**SOUTH COAST AIR QUALITY MANAGEMENT DISTRICT**

**ENGINEERING AND COMPLIANCE  
APPLICATION PROCESSING AND CALCULATIONS**

**Rule 1420.1 Plan**

RULE 1420.1 COMPLIANCE PLAN

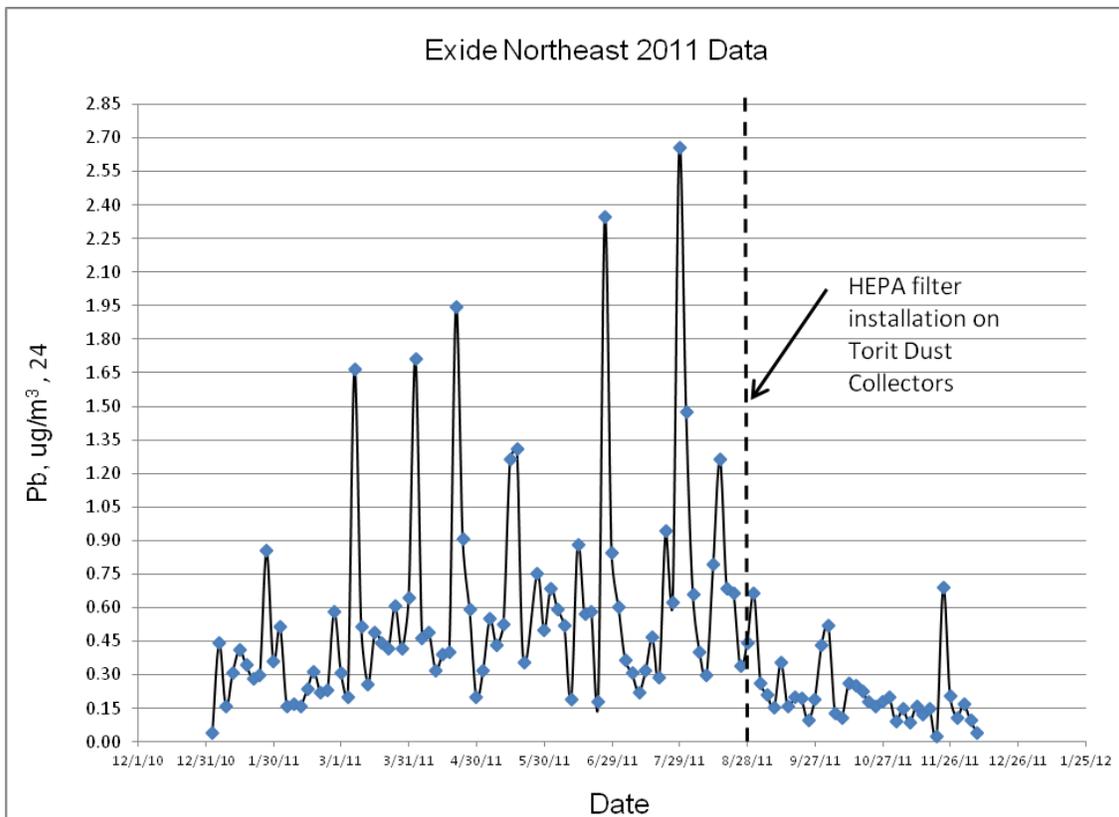
The most prominent effect has been recorded at the North East monitoring station which is located at the corner of the smelter/warehouse building. The following chart illustrates the apparent effect of the HEPA filter installations on the rotary dryer baghouse outlet and the two outlets of the Torit room ventilators.

Notice that the amount of high concentration spikes almost completely disappears after the HEPA filter installation. While this did not solve the problem completely, significant progress was made. The full extent of the improvements will not be apparent until the baghouse area total containment building is completed. Secondary filter stages are important because they capture transient emission spikes due to breaches of the primary filter media and due to other transient effects such as the pulse jet cleaning of baghouses and dust collectors.

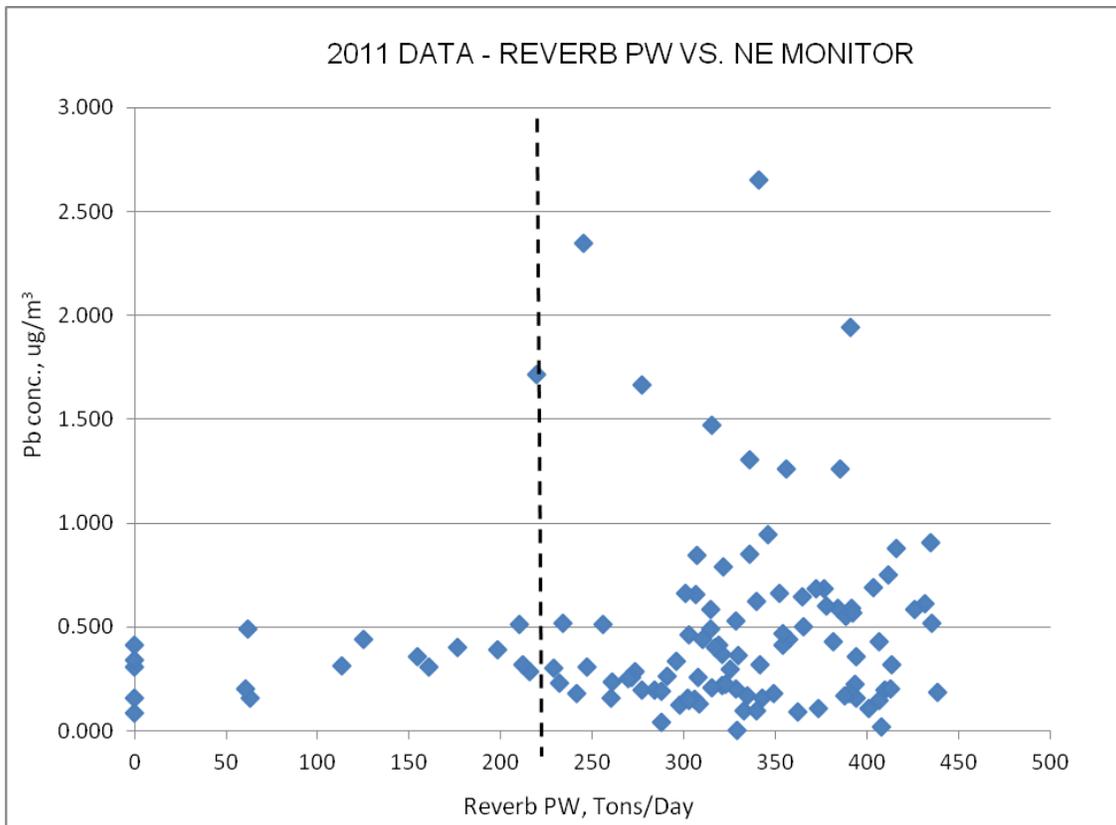
Another mitigation measure which has been controversial in the past is the reduction of process feed rate. Previously, this measure was controversial because it was very difficult to make a correlation using a well behaved function from monitoring data which is very "noisy". However, in 2011, following the implementation of control measures previously discussed, many variables have been eliminated which now allow the clearer manifestation of process rate related correlations regarding this operation. Specifically, it has been discovered that the process feed rate of the reverberatory furnace in 2011 indicates that spikes in the 24 hour average ambient lead concentrations at the Northeast monitoring station tend to occur more frequently above a certain feed rate. It is speculated that this phenomena is visible only now because in previous years there were too many degrees of freedom with regards to the release of fugitive emissions. The following chart illustrates this effect following the implementation of many fugitive dust control measures.

The lead concentration data is "quiet" until a process rate of about 225 tons/day, corresponding to approximately 50% of permit limit process rate. Above this level, there are many recorded spikes in the lead concentration at the Northeast monitoring station. While it is very clear that a well behaved function cannot be correlated to this data, it is also very clear that above 50 percent of maximum process rate for the reverb and rotary dryer, the lead concentration measurements tend to exhibit a significant number of high concentrations. It is speculated that at higher process rates, the handling of larger feed amounts, anomalies such as periodic clogging of the feed conveyor system, and possible effects on the rotary dryer baghouse filter media could occur. The installation of the secondary stage HEPA filter on this baghouse should resolve problems related to transient malfunctions of the filter bag media but it will not address any feed system instabilities which may occur.
